A63 Castle Street Improvement, Hull

DCO Documents Errata

TR010016/APP/6.1
HE51408-MMSJV-GEN-S0-RP-ZH-000016
20 September 2019

Drawing Title: **VOLUME 2 FIGURE 2.5.4 THE SCHEME PROPOSALS - SHEET 3 OF 8**

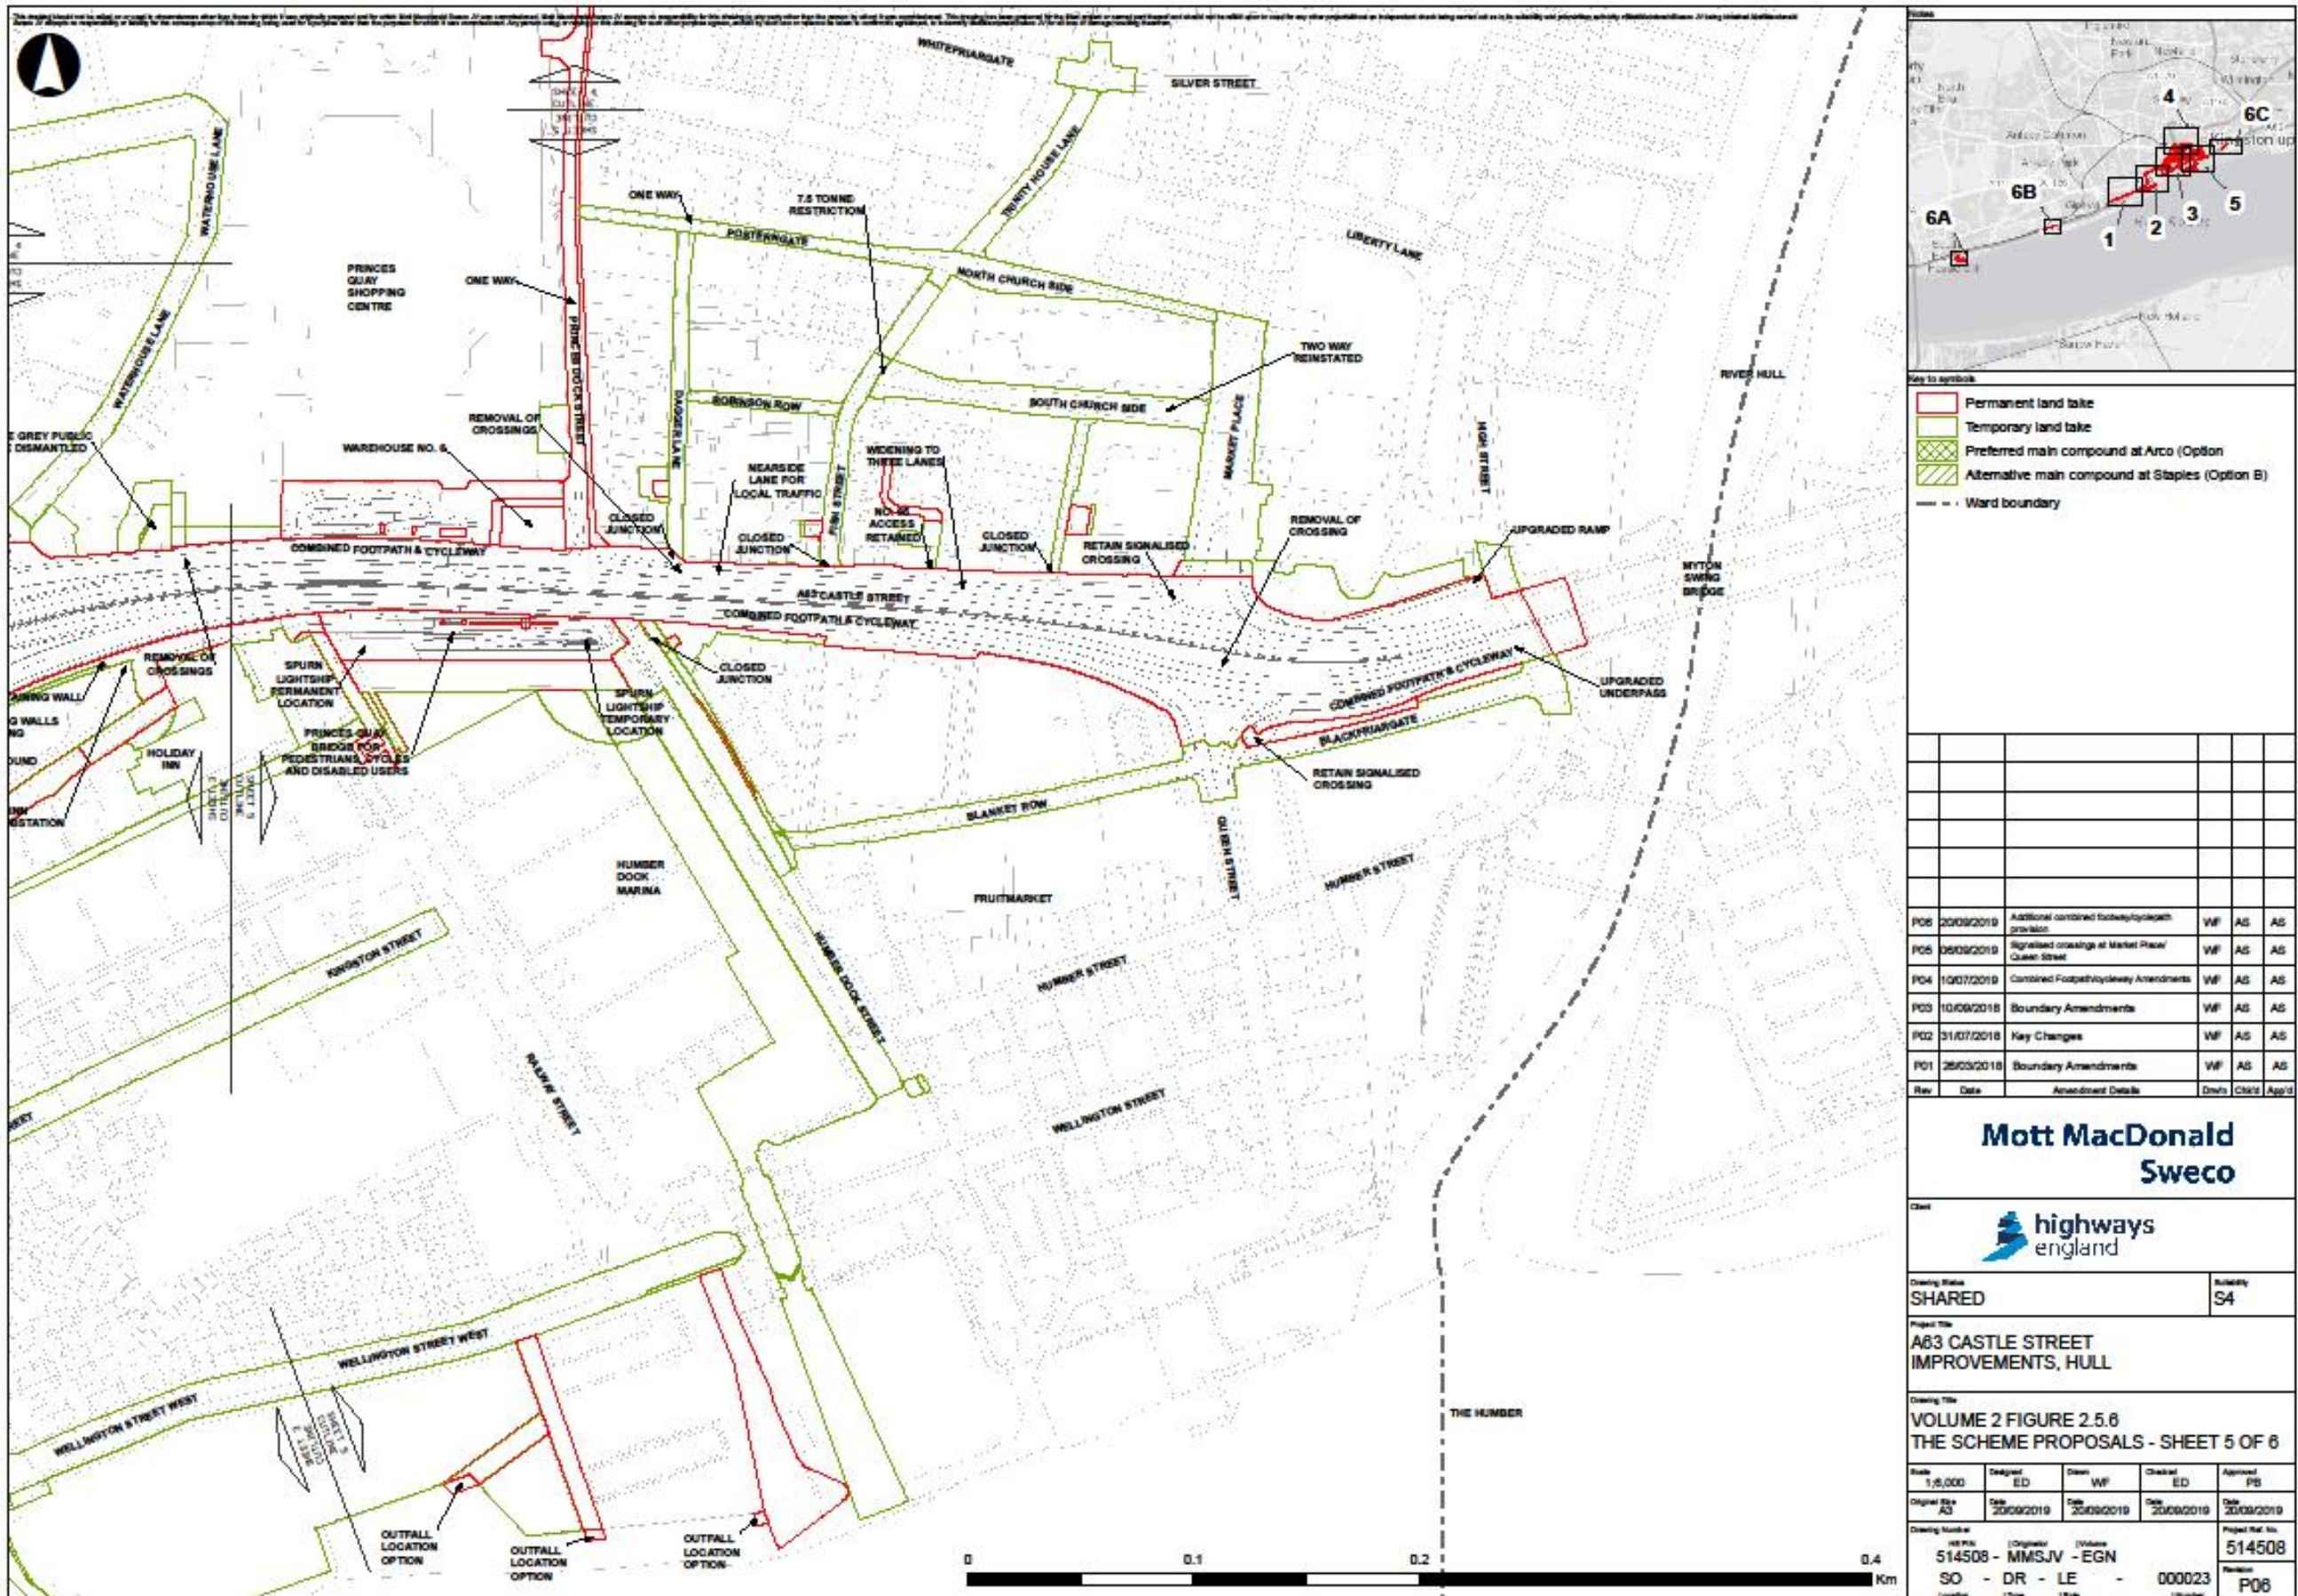
- 3.1.1 Replace ES Volume 2 Figure 2.5.4 The Scheme Proposals – Sheet 3 of 6 and Figure 2.5.6 The Scheme Proposals – Sheet 5 of 6 (APP-025) with the new Figures 2.5.4 and 2.5.6 below. Changes are as follows:
- Locations of the combined footpath & cycleway have been revised.
 - Signalised crossings at Market Place and Queen Street are to be retained.

Drawing Title: NON-STATUTORY DESIGNATED SITES
 VOLUME 2 FIGURE 10.2

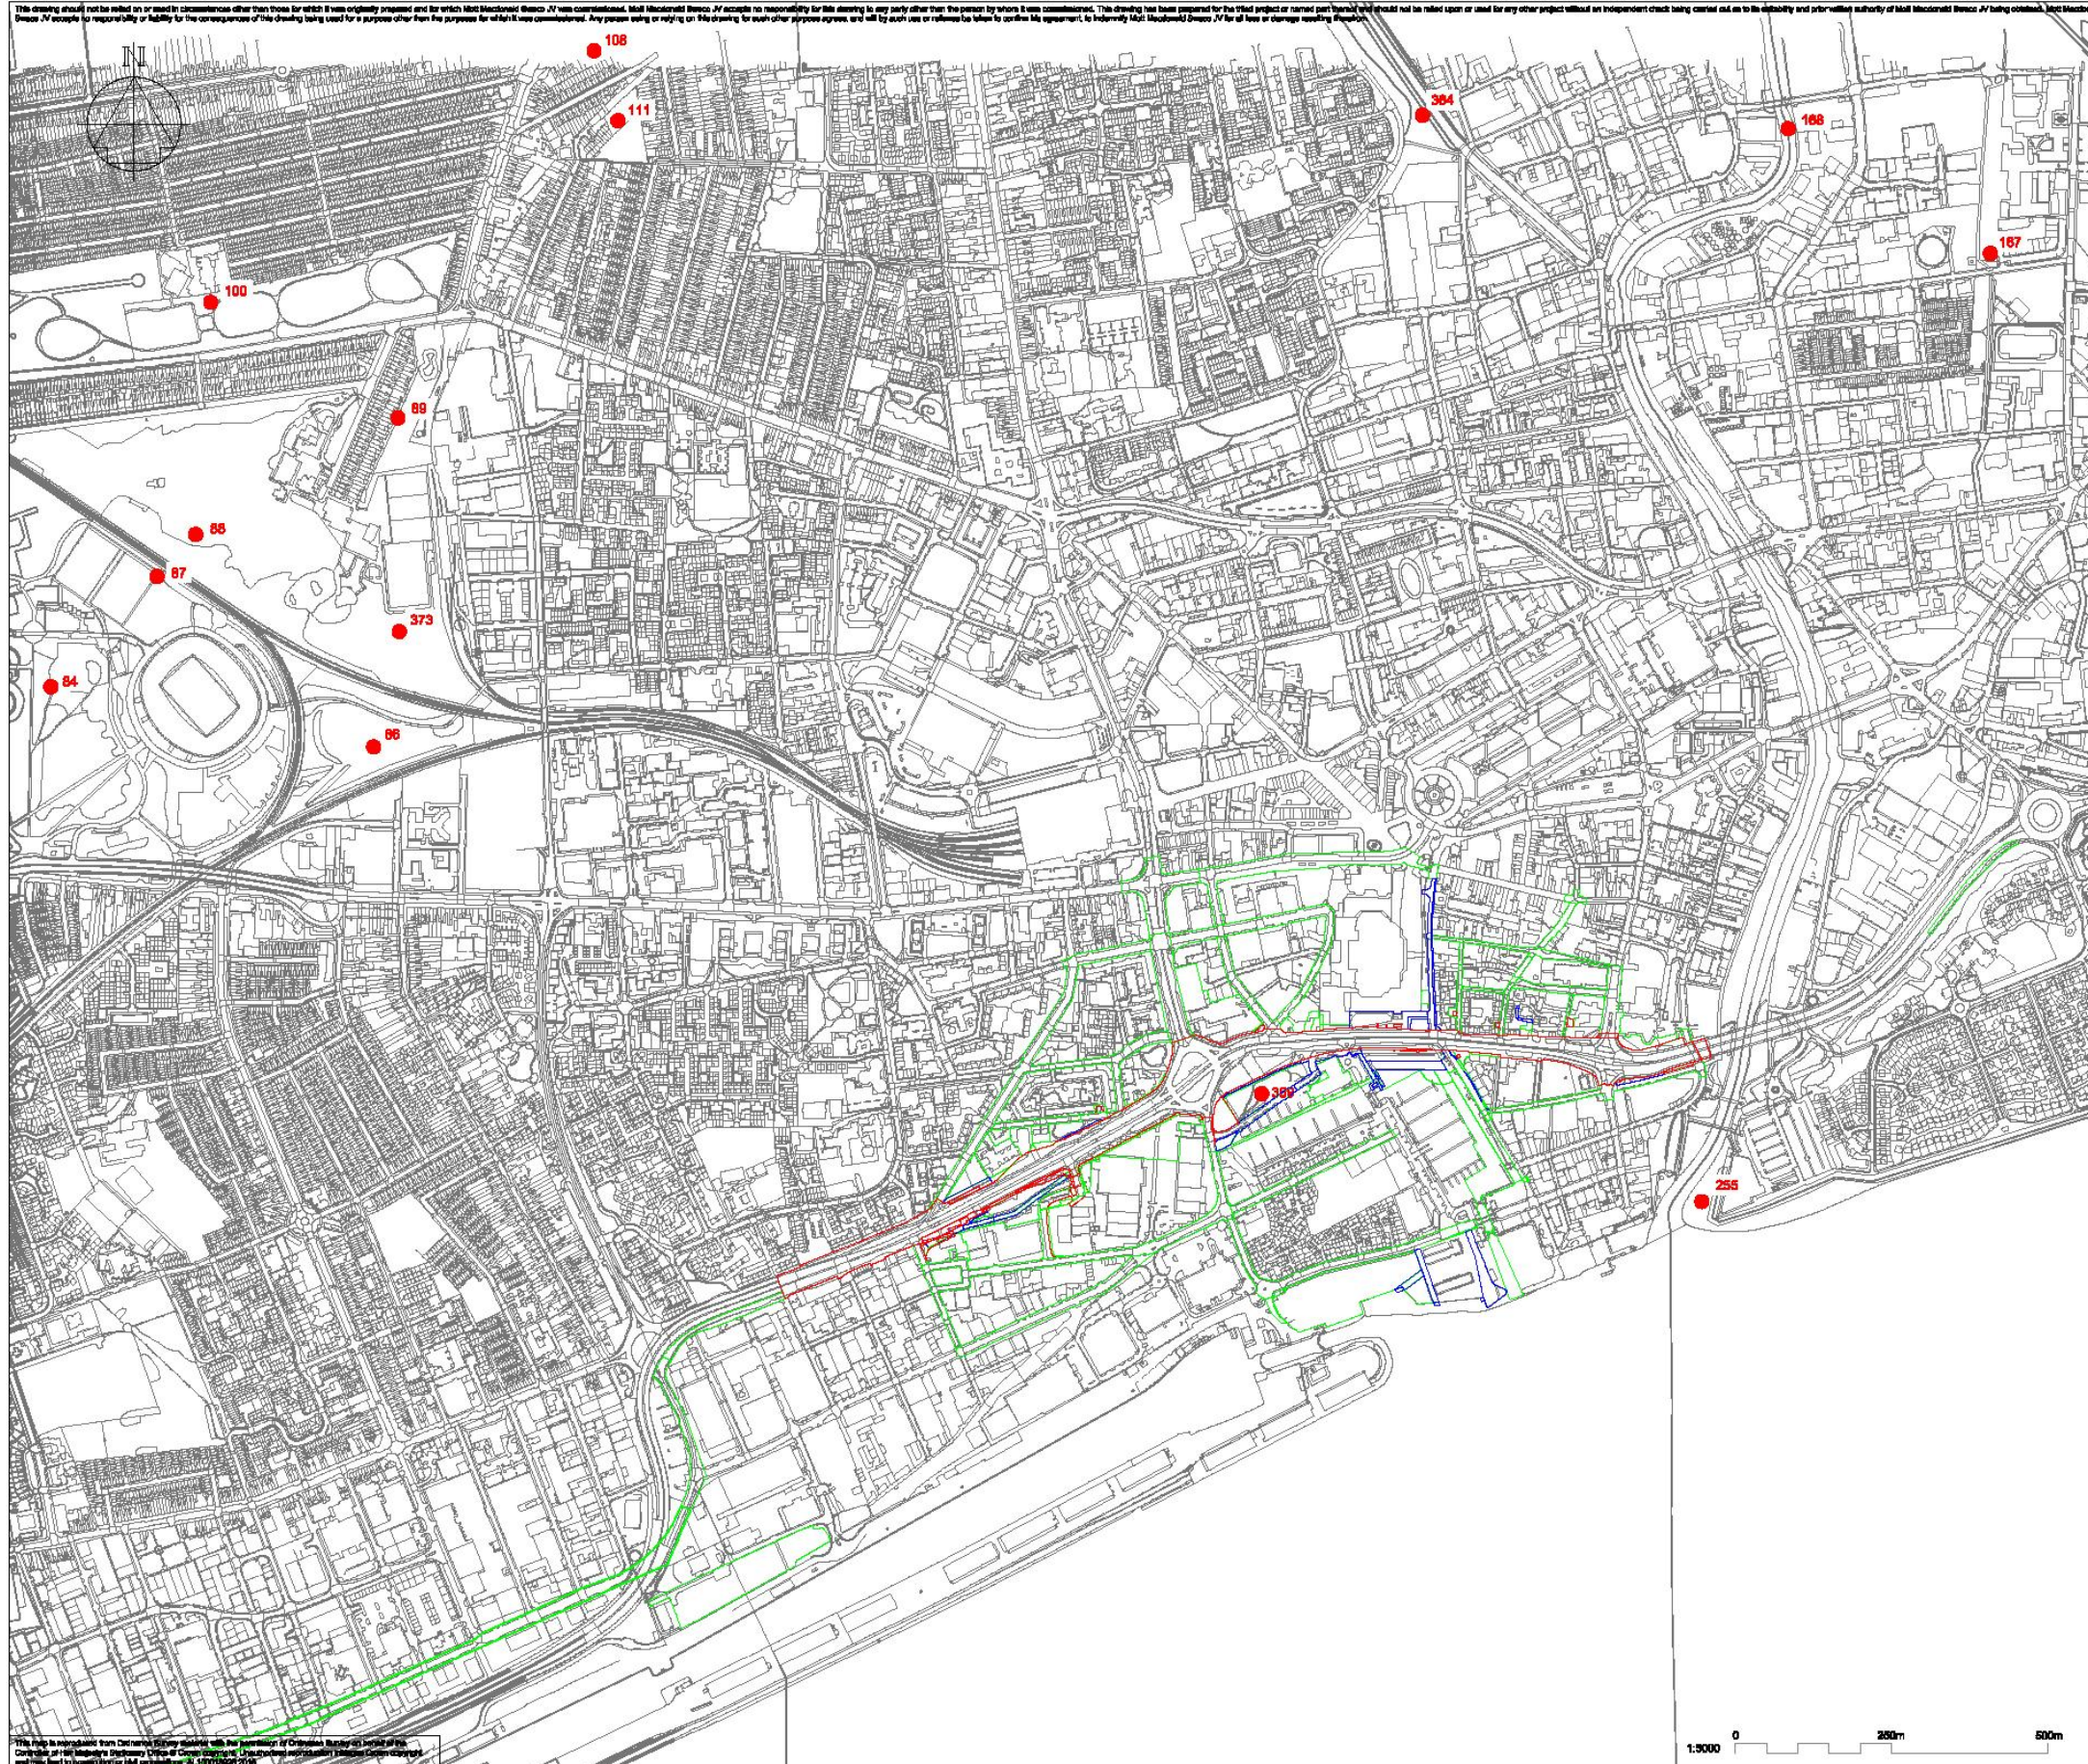
4.1.1 Replace ES Volume 2 Figure 10.2 Non-statutory designated sites (APP-036) with the new Figure 10.2 Non-statutory designated sites as below. Changes are as follows:

- The key has been replaced.
- Sammy's Point Site of Nature Conservation Interest (SNCI) has been added to Figure 10.2 as the mudflats are 250m from the Site boundary.

5.1.1 Replace ES Volume 2 Figure 15.2 Proposed non-motorised users facilities and closure for the Scheme (APP-040) with the revised Figure 15.2 as below. Changes are as follows:

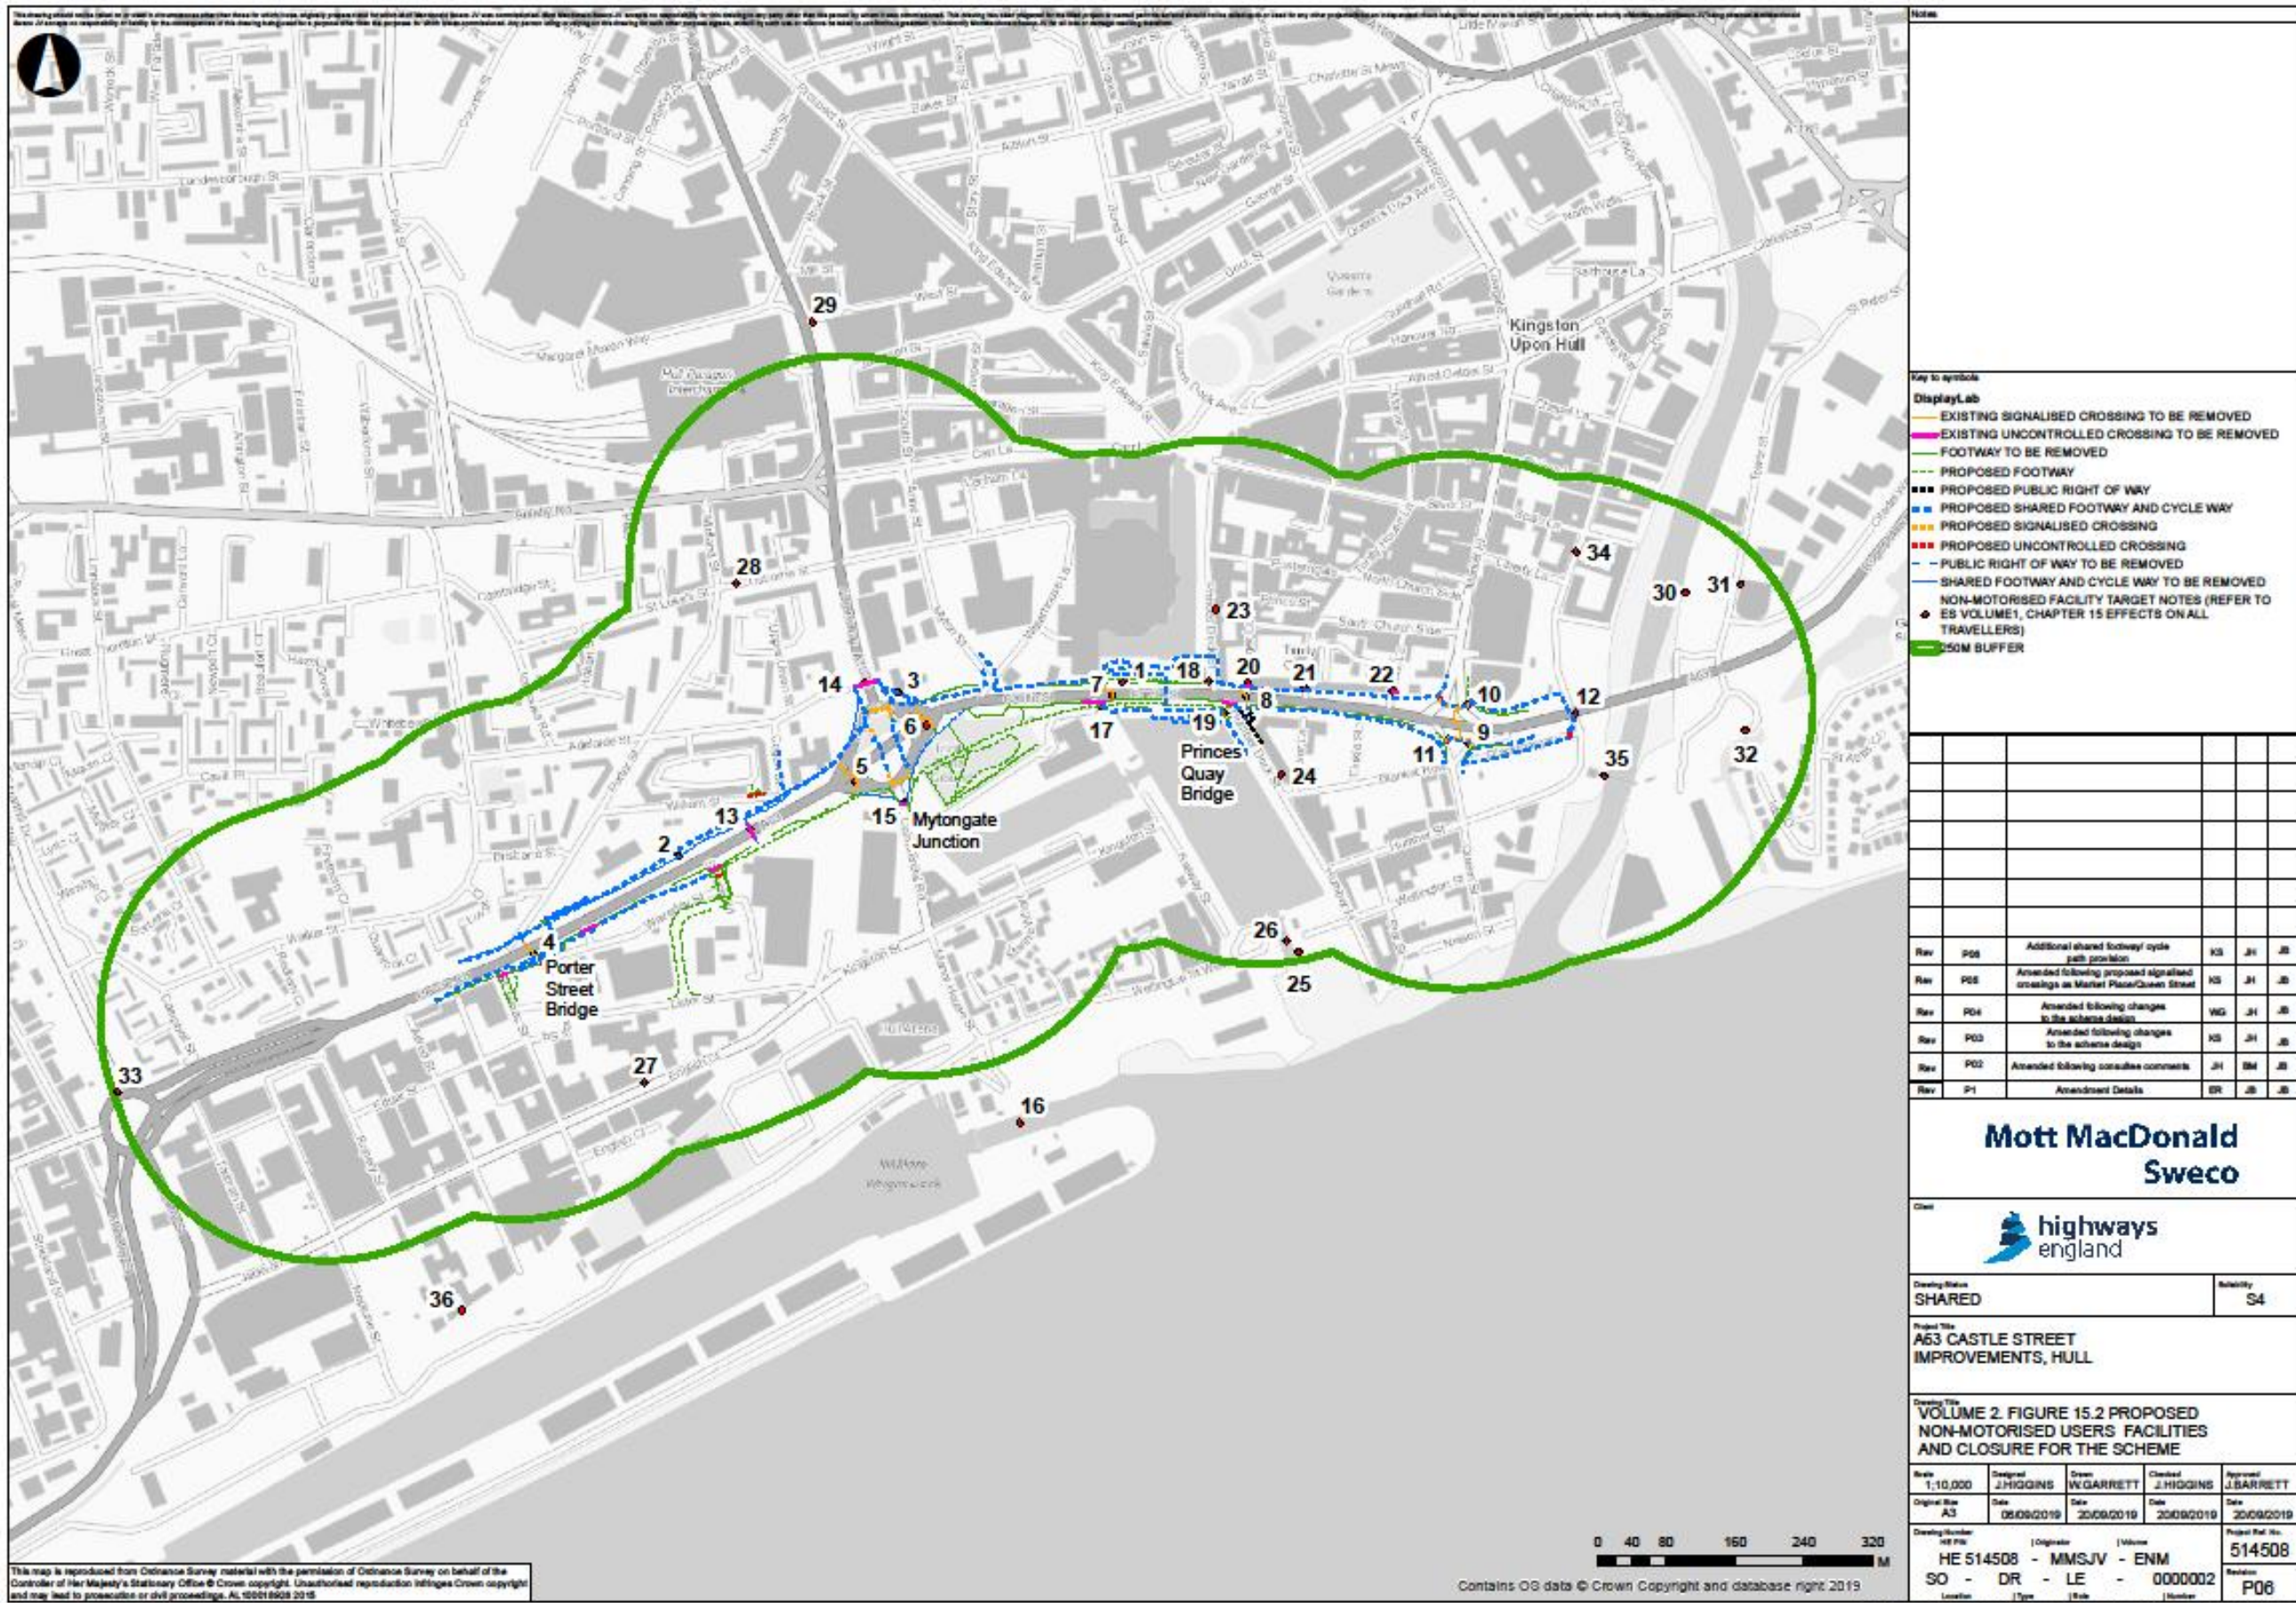
- Locations of the combined footpath & cycleway have been revised.
- Signalised crossings at Market Place and Queen Street are to be retained.
